HISTORIC AND DESIGN REVIEW COMMISSION

February 16, 2022

HDRC CASE NO: 2022-079
COMMON NAME: Brackenridge Park
ADDRESS: 3700 N ST MARYS ST
ZONING: R-6,HS
CITY COUNCIL DIST.: 2
LANDMARK: Individual Landmark
APPLICANT: Jamaal Moreno/City of San Antonio - PWD
OWNER: City of San Antonio - PWD
TYPE OF WORK: Removal of heritage and significant trees at top of bank and along the river
APPLICATION RECEIVED: January 28, 2022
60-DAY REVIEW: *Not applicable*

The applicant is requesting a Certificate of Appropriateness for approval to remove significant and heritage caliper trees located on the banks of the San Antonio River. This includes 3 heritage Live Oaks, 2 heritage Pecans, one heritage Bald Cypress, and one heritage Crepe Myrtle located along the river banks in the Lambert Beach area. It also includes a number of significant trees measuring as small as 2" in diameter and up. The scope of work is related to a 2017 Bond project that will be submitted for review and recommendation at a future date. The Planning Commission approved a variance to Tree Preservation requirements related to this request on January 26, 2022.

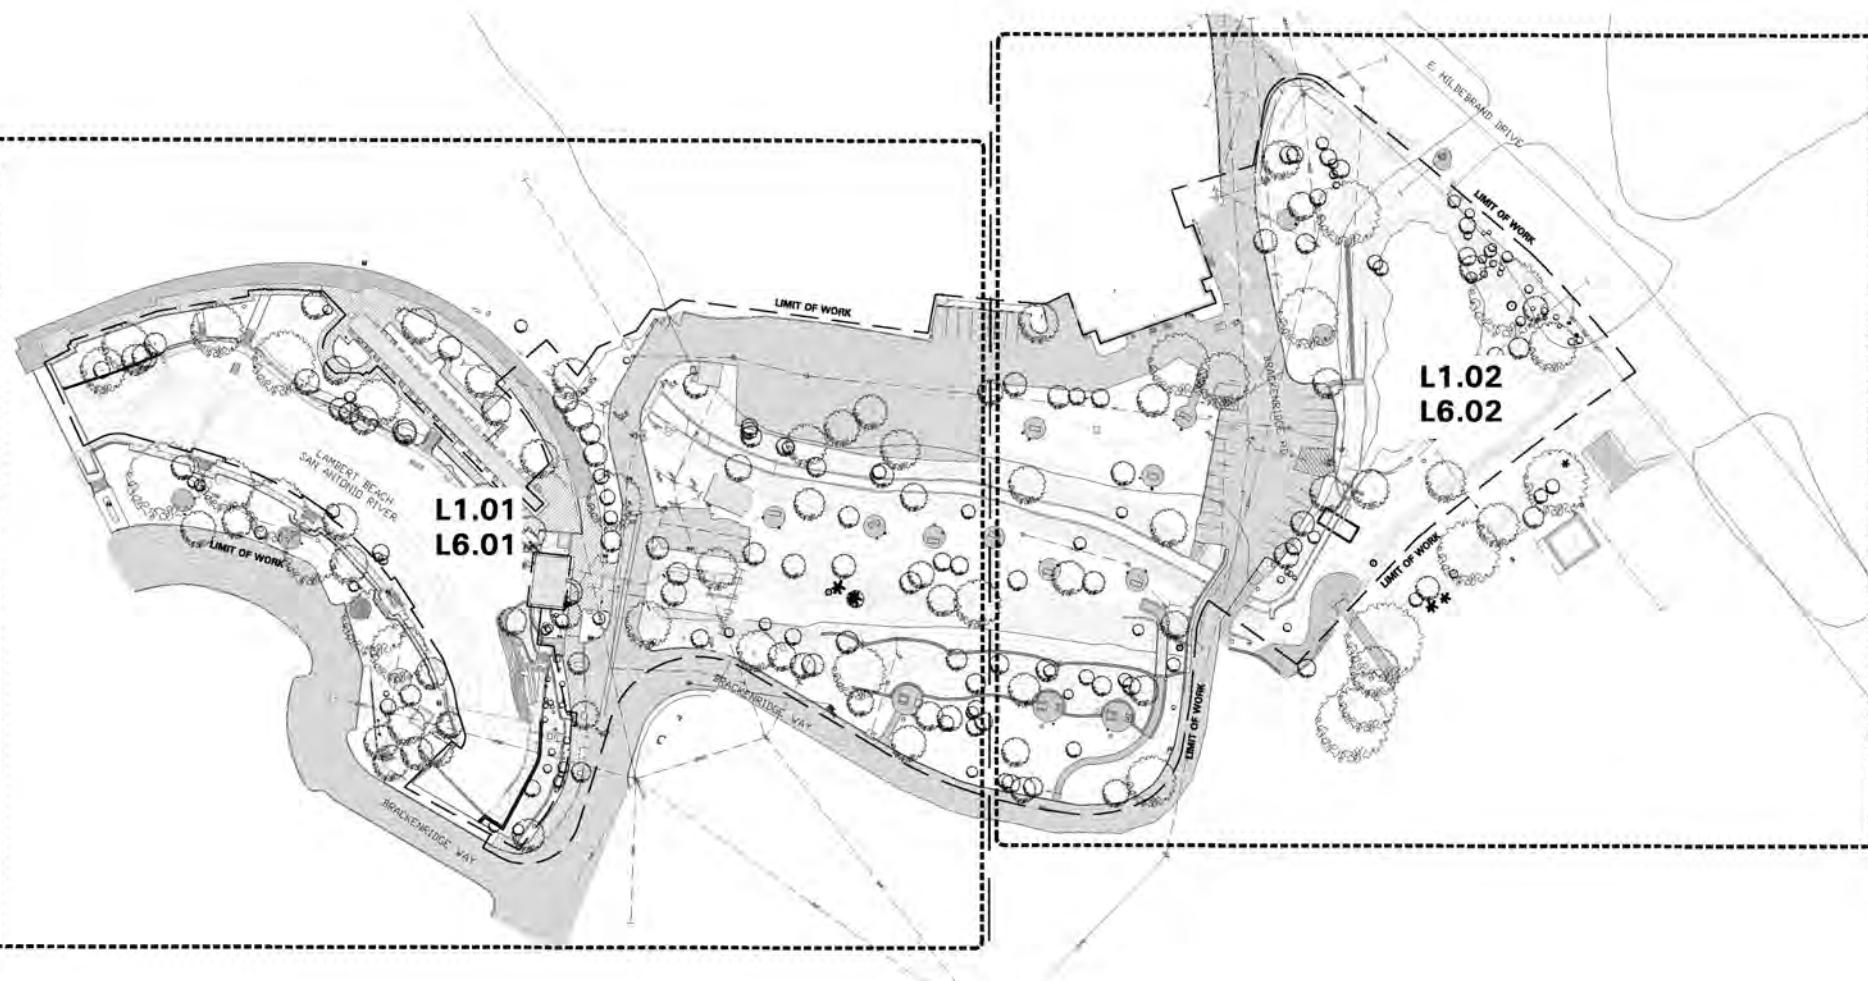
- e) CHANNEL WALLS – The Lambert Beach area is framed by stone walls as well as concrete stairs and landings which were constructed ca. 1925. Additional work in the area was likely completed by the National Youth Administration and Works Progress Administration between 1935 and 1940. Some portions immediately adjacent to the Pump House date to ca. 1877. Preliminary consultations with the reviewing agencies indicated a preference to preserve historic walls and site features in place while considering the significance of the trees as they relate to the

cultural landscape of the park. As proposed, the walls will be repaired in place and reconstructed using salvaged and matching materials where required. Historic photos suggest that numerous Live Oak trees were present when the 1925 improvement where made. Tree growth in addition to erosion and general deterioration have contributed to the failure of the existing walls. Significant bowing and structural separation are evident in the existing walls. These walls cannot be feasibly repaired without addressing the proximity of the trees. Trees noted for removal that immediately impact a historic feature and require monitoring during removal are noted in yellow on the attached plans. This includes 3 heritage Live Oaks, 2 heritage Pecans, one heritage Bald Cypress, and one heritage Crepe Myrtle located along the river bank in the Lambert Beach area.

Staff recommends approval of the proposed plan as recommended by the City Arborist. More than 400 new trees will be planted within Brackenridge Park, including 219 trees in the project vicinity.
